Re: Amendment to MRP for Re-mining of Fossil Rock Waste Rock Facility, Canyon Fuel Company, LLC,
Permit Number C/015/0009

Title: Amendment for Re-mining of Fossil Rock Waste Rock Facility

**FOSSIL ROCK MINE
WASTE ROCK STORAGE FACILITY
COMPLETED CONSTRUCTION MAP**

4-5

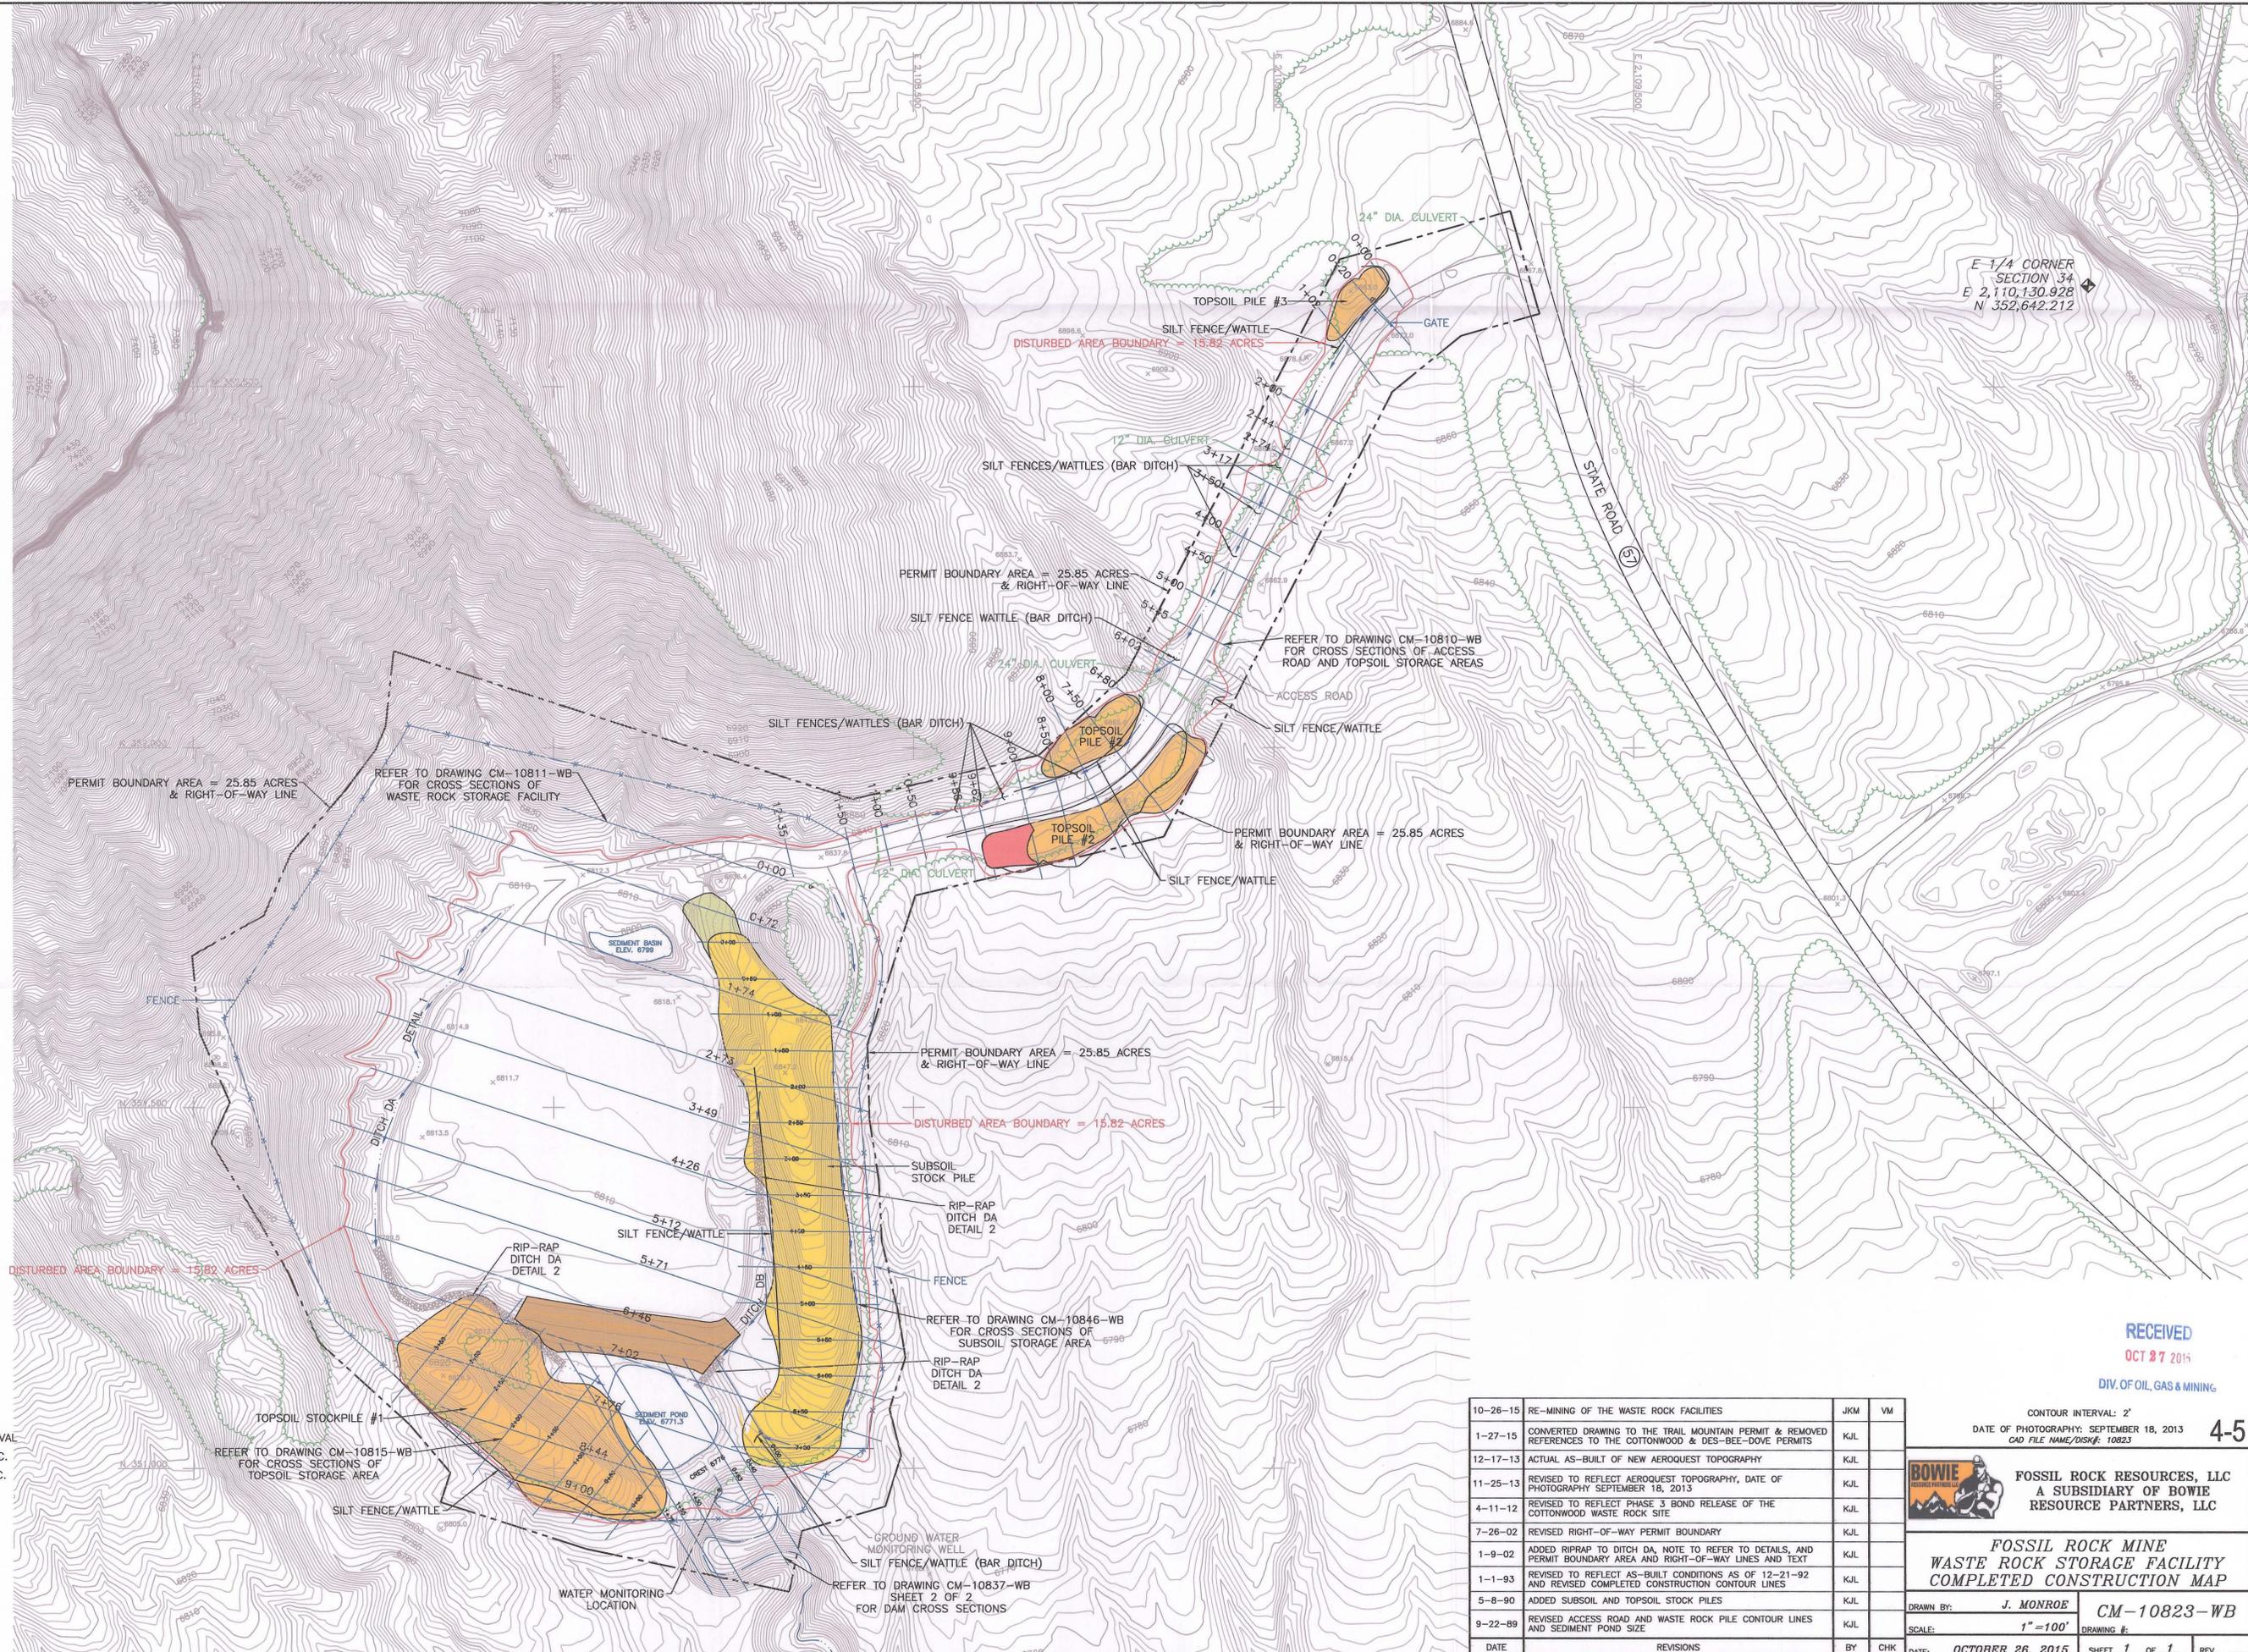
In 2015/2016 a plan is proposed to re-mine the waste rock site and salvage contemporaneously placed soils if they will be impacted by the re-mining process. Only the southern slope (18,183 square feet) adjacent to the sediment pond of the existing waste rock pile appears to have salvageable soils for storage. The other slopes have a mixture of coal waste with some soil, which will not be salvaged/stockpiled.

Plate 4-5 will be updated with changes in topography of the waste rock pile as the re-mining progresses, at a minimum annually until the re-mining project is completed (refer to Section 231.100 for as-built commitment). Annual Total Coal produced from re-mining will be documented in the quarterly waste rock inspection (see Section 514).

DATE	REVISIONS	BY	CHK
10-26-15	RE-MINING OF THE WASTE ROCK FACILITIES	JKM	VM
1-27-15	CONVERTED DRAWING TO THE TRAIL MOUNTAIN PERMIT & REMOVED REFERENCES TO THE COTTONWOOD & DES-BEE-DOVE PERMITS	KJL	
12-17-13	ACTUAL AS-BUILT OF NEW AEROQUEST TOPOGRAPHY	KJL	
11-25-13	REVISED TO REFLECT AEROQUEST TOPOGRAPHY, DATE OF PHOTOGRAPHY SEPTEMBER 18, 2013	KJL	
4-11-12	REVISED TO REFLECT PHASE 3 BOND RELEASE OF THE COTTONWOOD WASTE ROCK SITE	KJL	
7-26-02	REVISED RIGHT-OF-WAY PERMIT BOUNDARY	KJL	
1-9-02	ADDED RIPRAP TO DITCH DA, NOTE TO REFER TO DETAILS, AND PERMIT BOUNDARY AREA AND RIGHT-OF-WAY LINES AND TEXT	KJL	
1-1-93	REVISED TO REFLECT AS-BUILT CONDITIONS AS OF 12-21-92 AND REVISED COMPLETED CONSTRUCTION CONTOUR LINES	KJL	
5-8-90	ADDED SUBSOIL AND TOPSOIL STOCK PILES	KJL	
9-22-89	REVISED ACCESS ROAD AND WASTE ROCK PILE CONTOUR LINES AND SEDIMENT POND SIZE	KJL
